Service-Information Motorcycle

May 1990
46 027 90
(2405)

R100GS Paris-Dakar Engine Spoiler/Low Front Fender

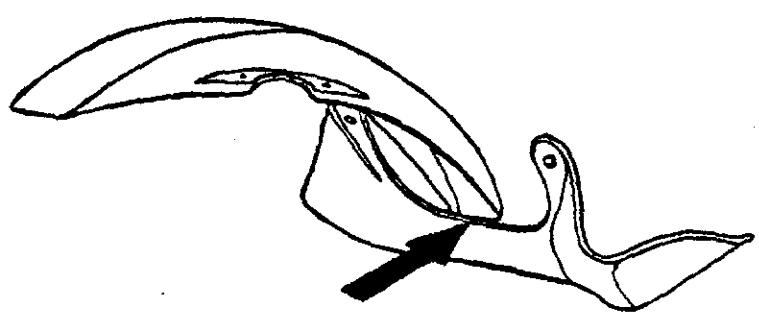
A low front fender for the 1988 and 1989 R100GS models must not be used in conjunction with the engine spoiler of the Paris-Dakar models. When traversing rough terrain or large bumps (especially while applying the front brake under these circumstances), the rear edge of the fender could catch on the engine spoiler.

All U.S. version R100GS Paris-Dakar motorcycles were ordered with the high fender (with stabilizer and extension tip). Only the high fender can be used with the Paris-Dakar engine spoiler. Please advise customers that changing to a low fender is not allowed.

When selling Paris-Dakar components through the parts system, also advise purchasers that the engine spoiler is not compatible with the low front fender equipped on 1988 and 1989 models and should not be sold for this purpose.

All Paris-Dakar engine spoiler kits sold through the parts department will carry a label advising purchasers of the incompatibility with the low front fender. If you have an engine spoiler kit in your parts stock, please contact your Technical Services Manager (at 800-642-9253), who will ship you a label to attach to it.
